RF
Circuit

PCB		APR:	CHK:	DWG:
Title		TwinTouch SE		
Size	Document Number	Rev		
B	CKT:20310006101PCB:10230059100	5		
Date:	Tuesday, December 28, 2004	Sheet	1 of 1

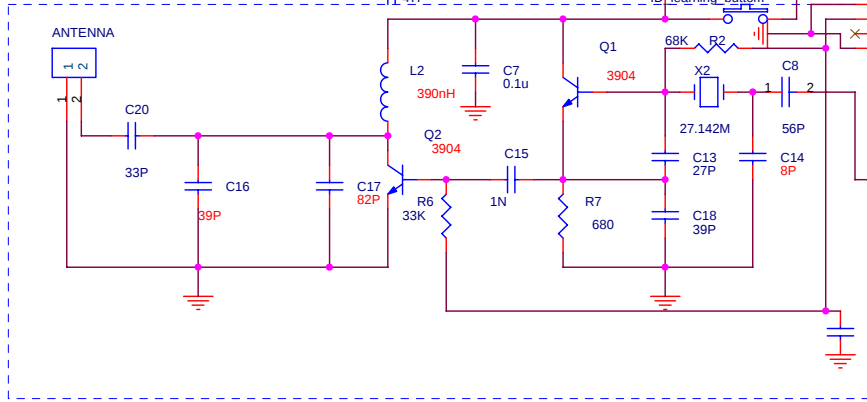
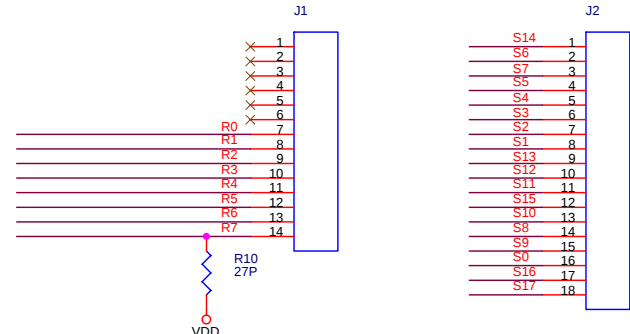
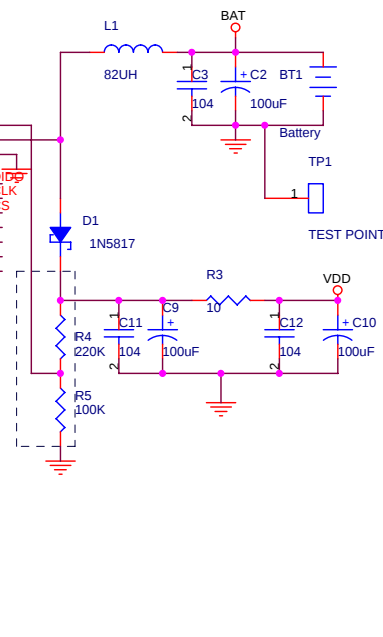
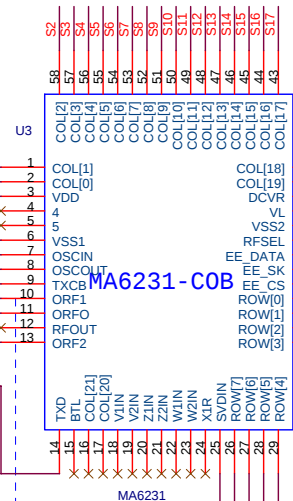
Date:2004-08-17
Rev:2
Add
MA6231 第四, 五脚接地
R12

Date:2004-09-09
Rev:3
MA6231 包装QFP改COB

Date:2004-09-09
Rev:4
更换RF线路, 将外挂AP移除, 移除Test Point, 电池正负极各串一1206电容
R0-R7各接一电容到地

Date:2004-12-28
Rev:5
MA6231 包装QFP改COB
依据第二版LAYOUT
只变动IC包装
